**Summary of and Comments on  
LIL Study Reports  
Issued in April 2020**

**The Board of Commissioners of Public Utilities  
Newfoundland and Labrador**

**The Liberty Consulting Group**

**June 9, 2020**

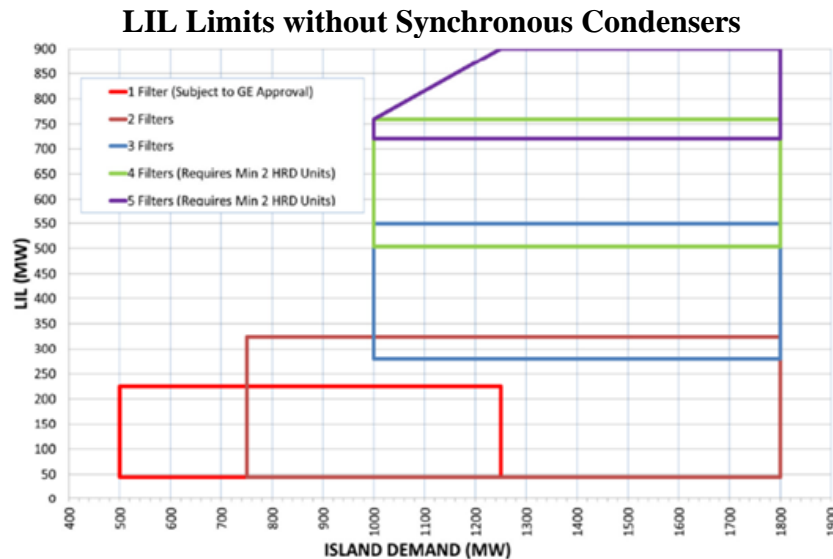
*Harmonic Filters* - - AC harmonic filters reduce to an acceptable level the harmonic distortion that operation of the HVDC converters will produce. These filters are switched in and out as the power on the LIL is increased and decreased, in order to control the ac voltage. Harmonic analysis by TGS has determined that the LIL can operate up to its full 900MW capability with just two filters. However, this assessment considers only harmonics. Reactive power/ac voltage control considerations produce a need for five in-service filters to support LIL operation at 900MW, to provide sufficient system voltage support.

Switching in a filter causes the voltage to rise. The ac voltage drops when switching out the filter. The voltage step resulting from the switching of a filter depends on the strength of the network (its short circuit level, or "SCL"). The SCL increases with more generation or synchronous condensers in service. Applicable planning criteria prescribe voltage step limits, which depend on the number of switching operations per day. With no synchronous condensers available, at least one Holyrood generating unit must be in service to permit switching the first two filters into service. Switching a third filter into service requires two Holyrood units in service. Five filters require all three Holyrood generating units in service. TGS found that having one synchronous condenser in service produced no violation of voltage step limits, even with no Holyrood generating units available.

**LIL Transfer Limits (with ML Frequency Controller Not In-Service)**

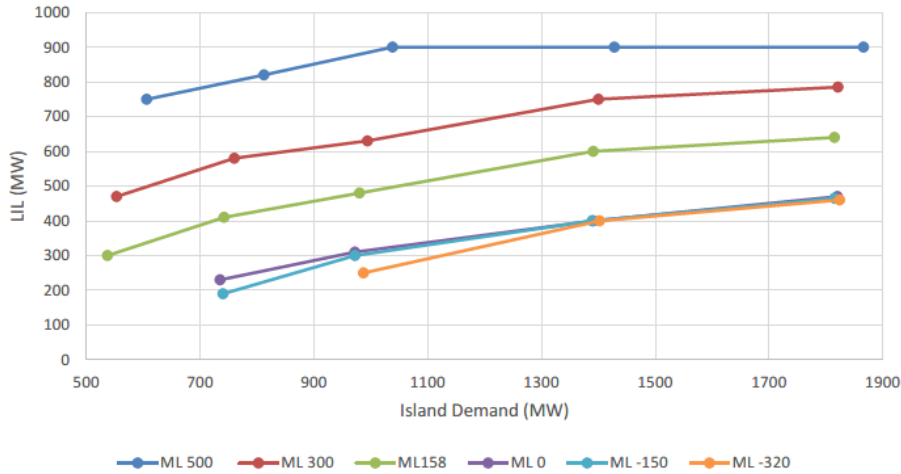
The next two figures show these LIL transfer limits as a function of demand on the IIS, considering the factors controlling them. The colored lines show these LIL limits at varying ranges of ML operation, from exporting 500MW (blue) to importing 320 MW (orange). The figures demonstrate, as expected, that the LIL’s ability to bring power to the IIS depends heavily on the magnitude and direction of power flow on the ML. The impact of ML frequency control, which may not always be available, also affects maximum power flows.
